CITY OF MADISON

PLAN OF PROPOSED IMPROVEMENT

N FRANKLIN AVENUE & LYNN TERRACE - ASSESSMENT DISTRICT 2025

CITY PROJECT NO. 15113
CONTRACT NO. 8766

D-6

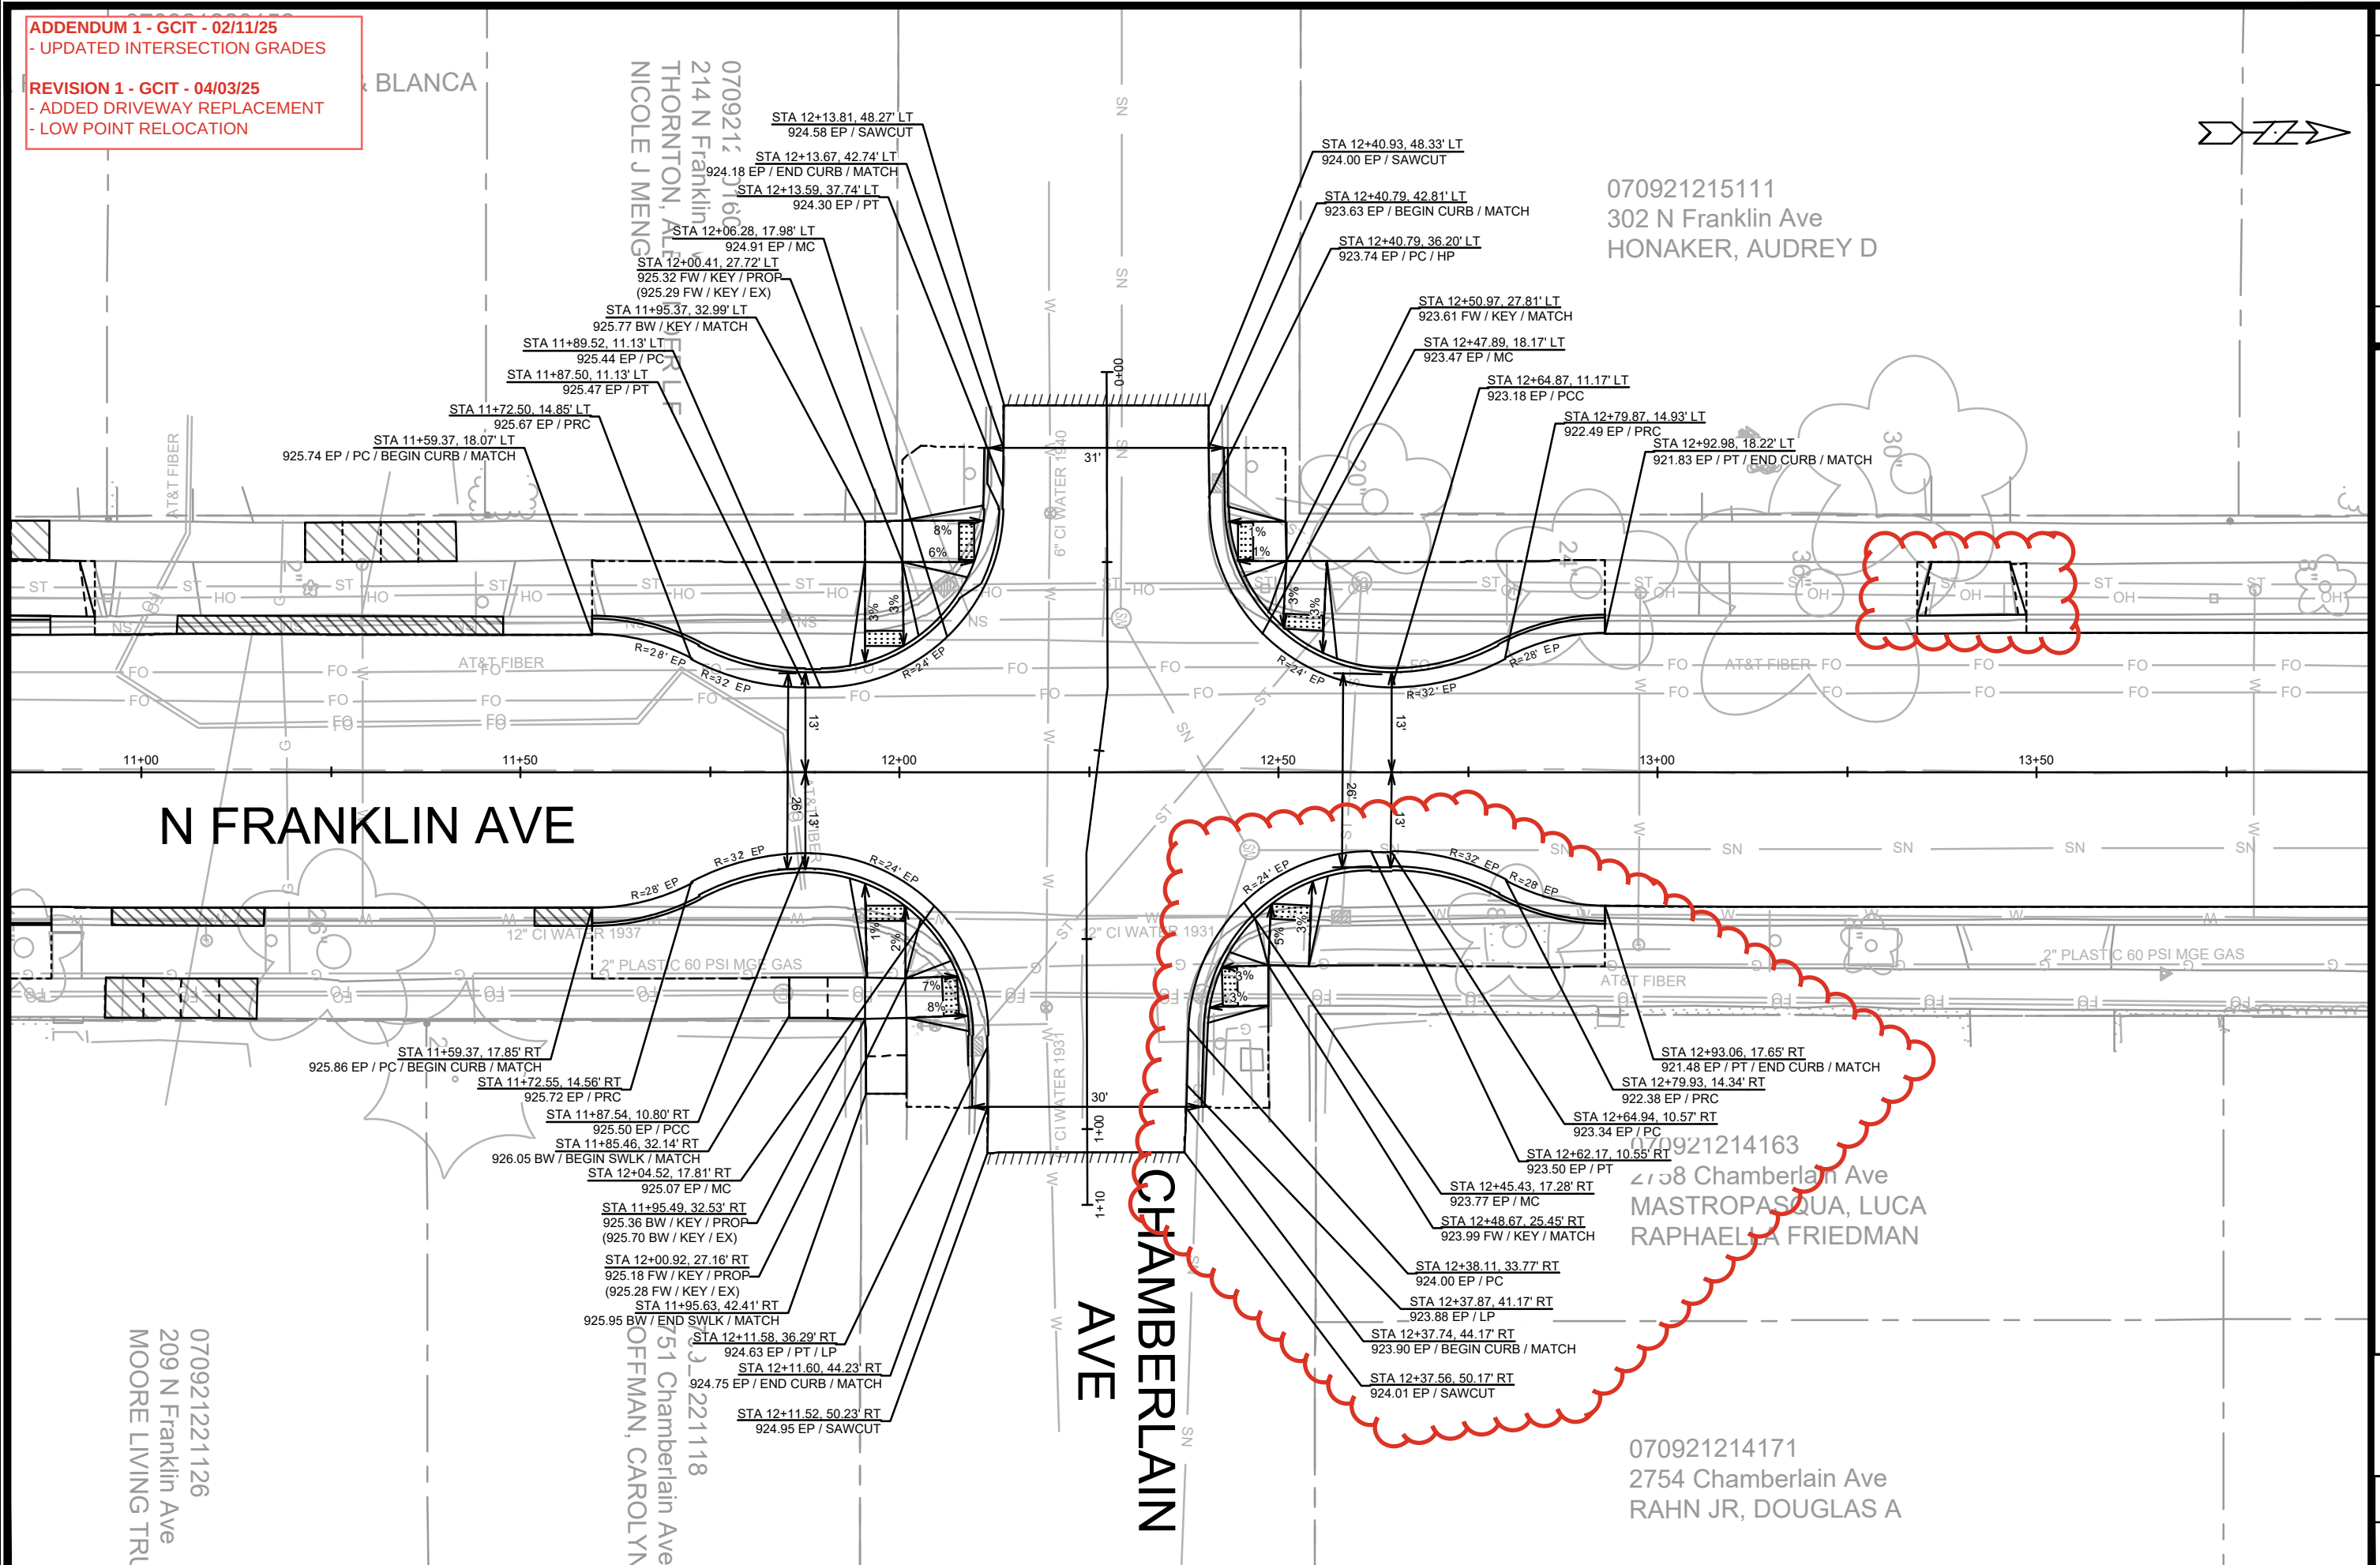
REVISION 1 - GCIT - 04/03/25
- ADDED DRIVEWAY REPLACEMENT
- LOW POINT RELOCATION

D-7

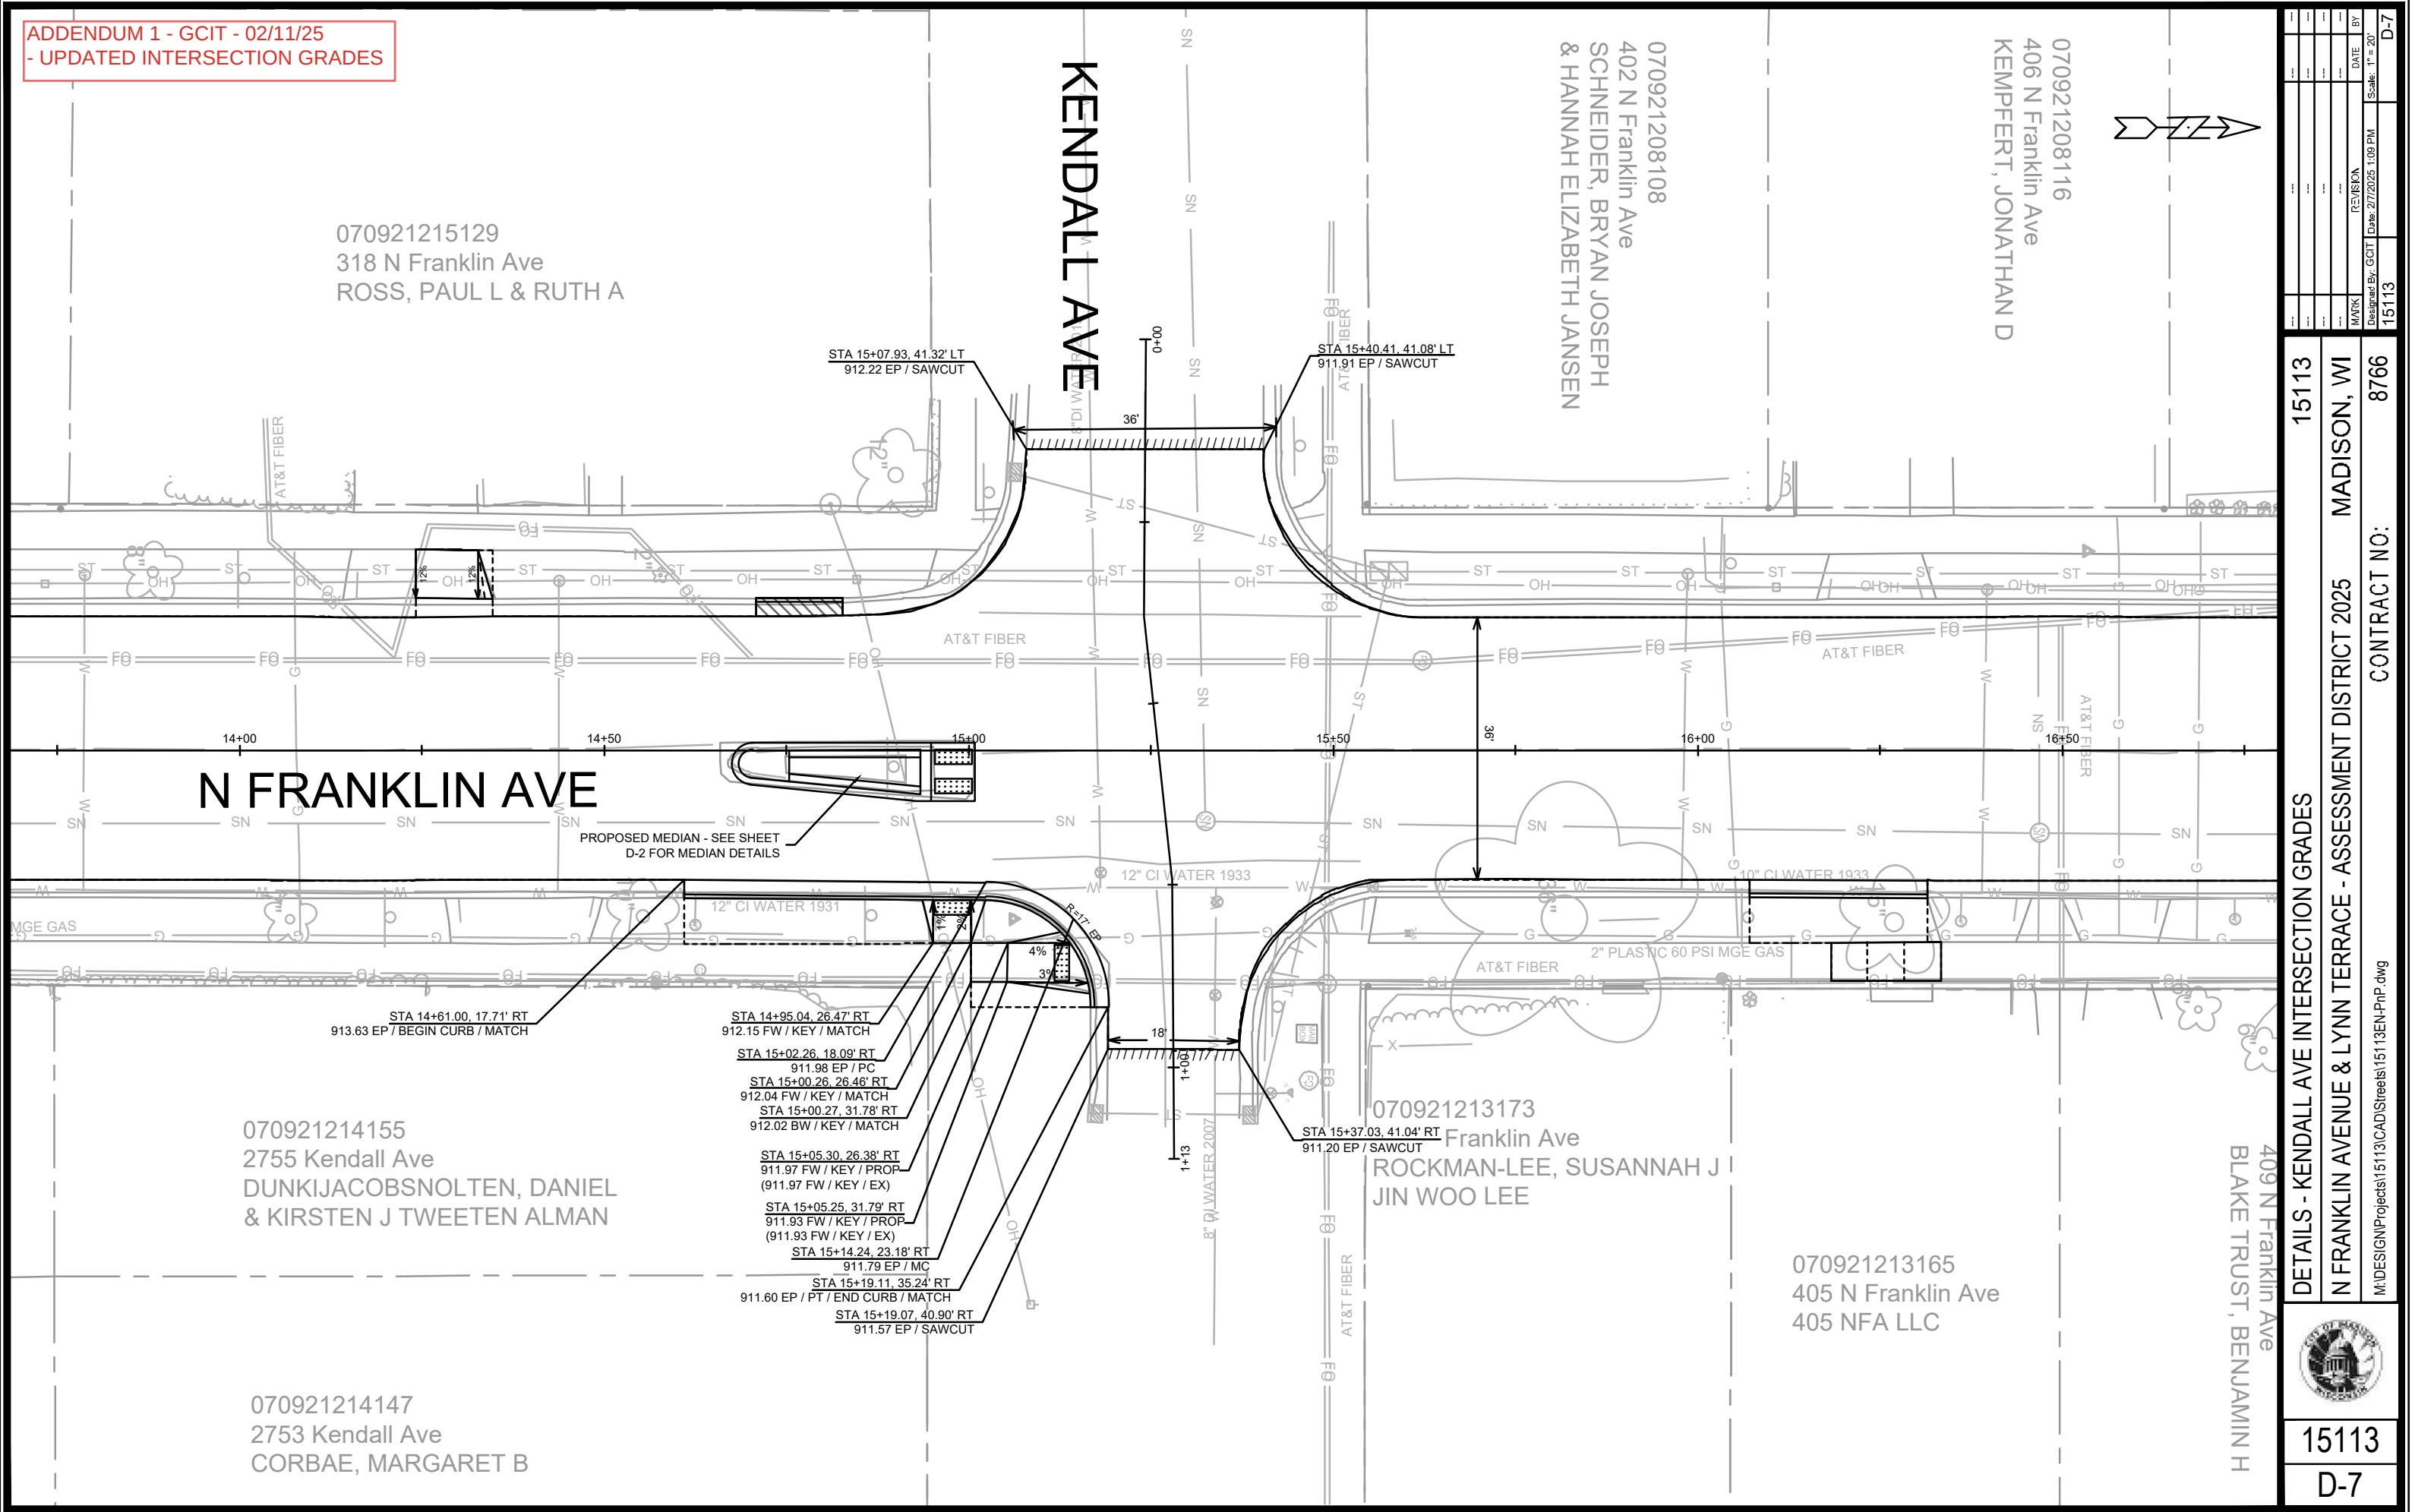
ADDENDUM 1 - GCIT - 02/11/25
- UPDATED INTERSECTION GRADES

15113	D-8
DETAILS - STEVENS ST INTERSECTION GRADES	
15113	
N FRANKLIN AVENUE & LYNN TERRACE - ASSESSMENT DISTRICT 2025	
MADISON, WI	
CONTRACT NO: 8766	
M:\DESIGN\Projects\15113\CAD\Streets\15113EN-PnP.dwg

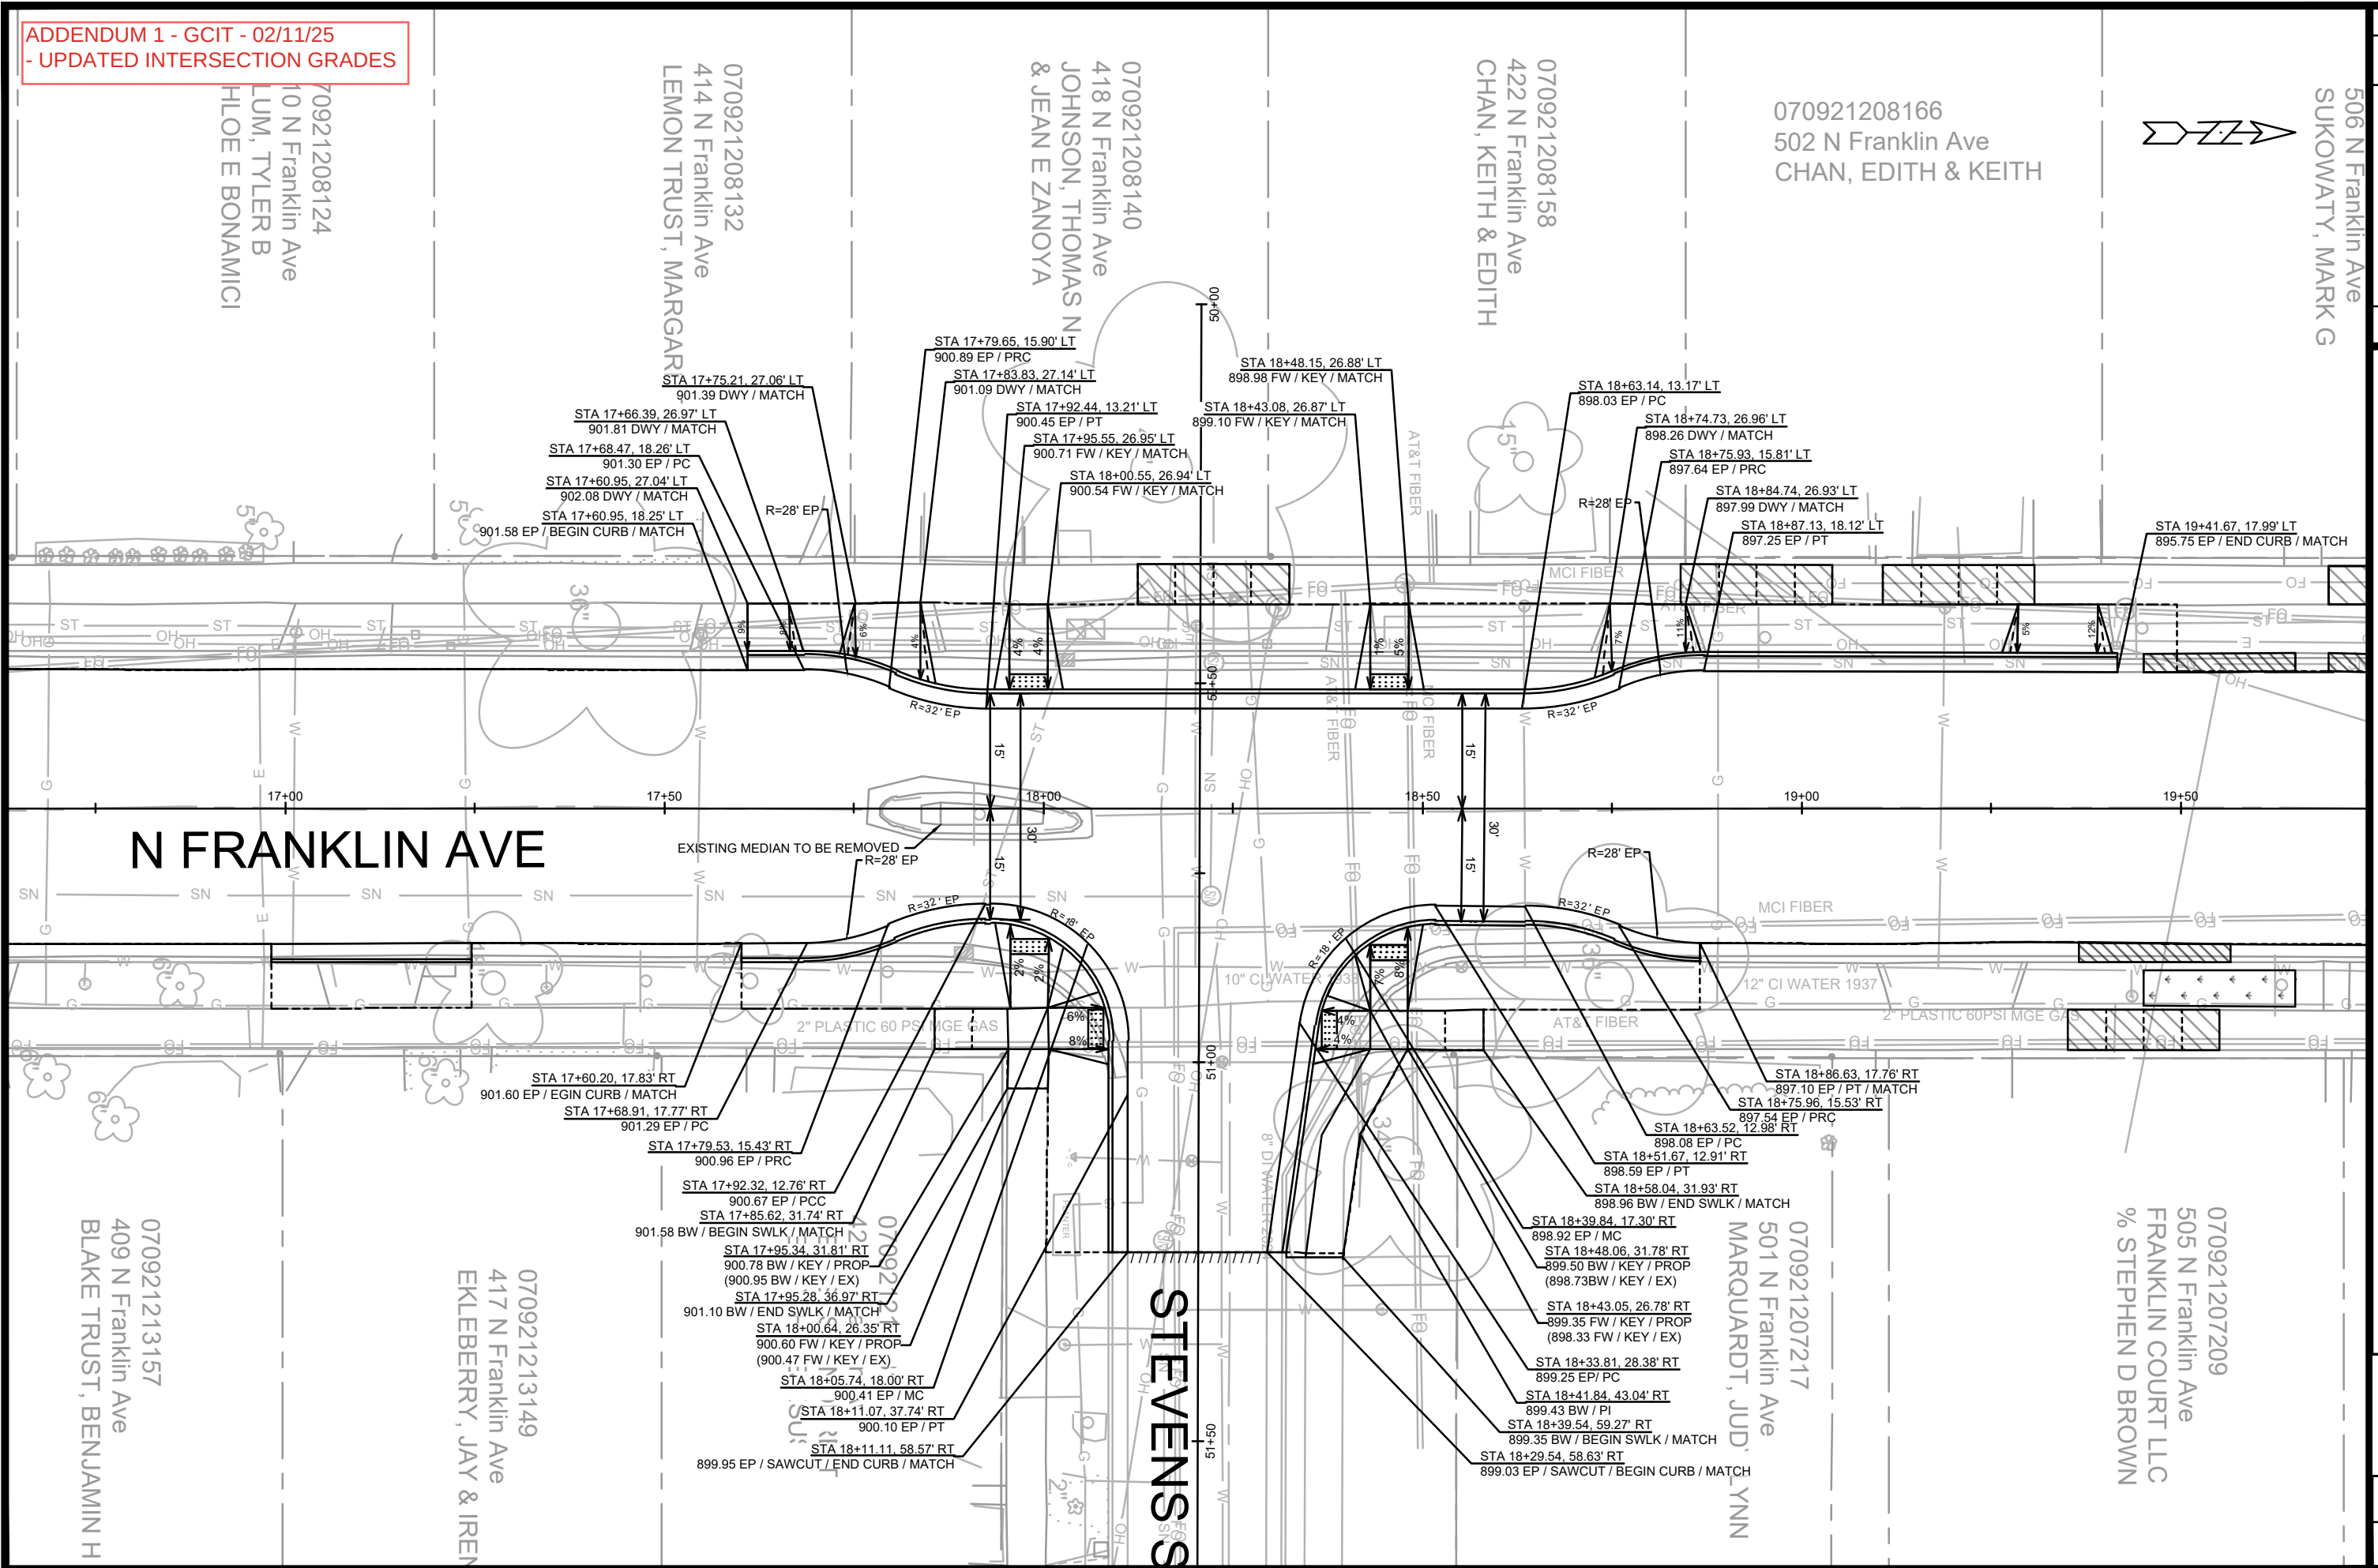
ADDENDUM 1 - GCIT - 02/11/25
- UPDATED INTERSECTION GRADES
